## PRODUCT BULLETIN

Bulletin No: PB287

Power Switch for Hakko 485, HJ3080, 700 Series

*Part No:* 485-63

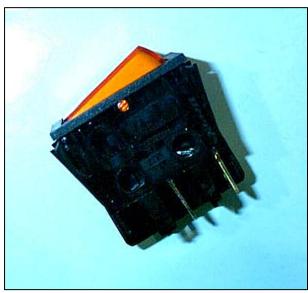
Hakko has changed the source for this power switch and as a result, the pin assignment for wiring has been changed.

Connection	Old Switch	New Switch
Power Supply Side	Connect 1 to 4	Connect 1 to 3
Load Side	Connect 2 to 5	Connect 2 to 4
